LATEST REVISION DATE 06-12 APPROVED BY BRIDGE ENGINEER <i>Thomas E. McQuill</i>	 STANDARD DESIGN - 40' ROADWAY, 3 SPAN BRIDGES CONTINUOUS CONCRETE SLAB BRIDGES NOVEMBER, 2006	
	SUPERSTRUCTURE DETAILS 150'-0 BRIDGE	J40-18-06

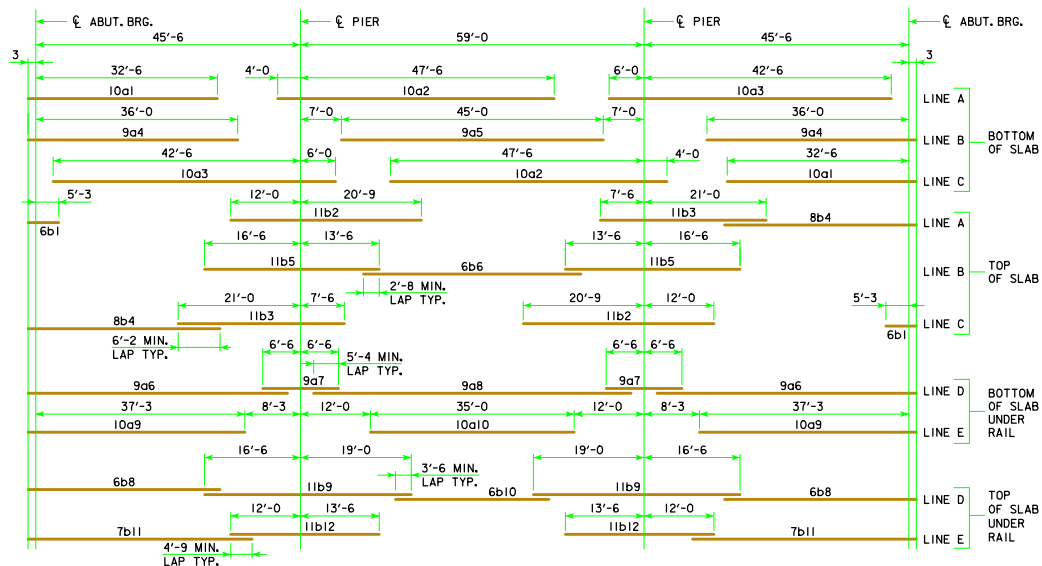
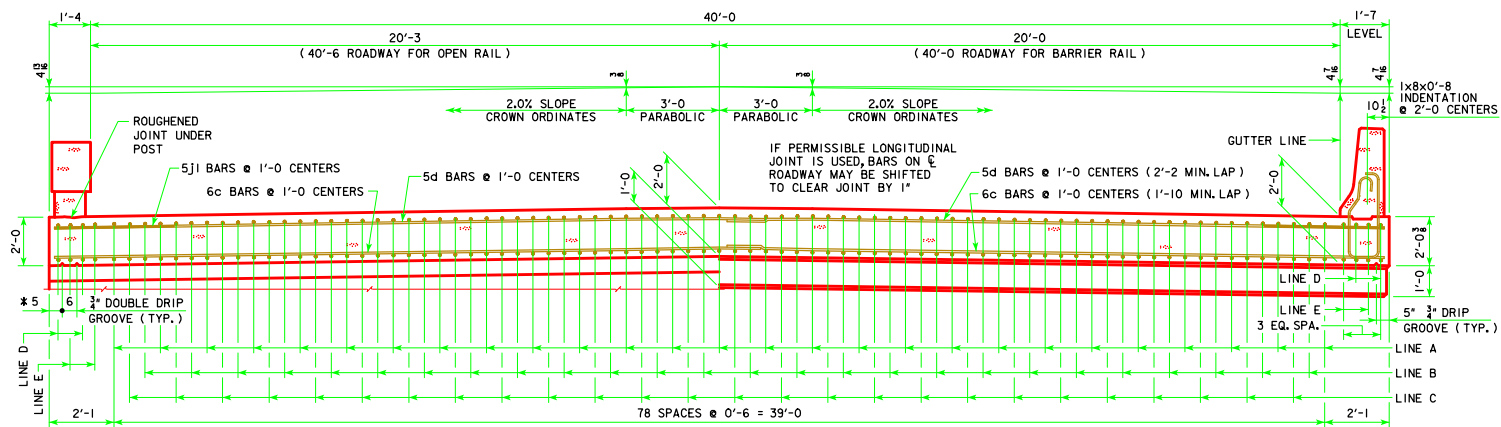
REVISED 06-12 - I.M. REQUIREMENT ADDED TO BAR CHAIR NOTE.
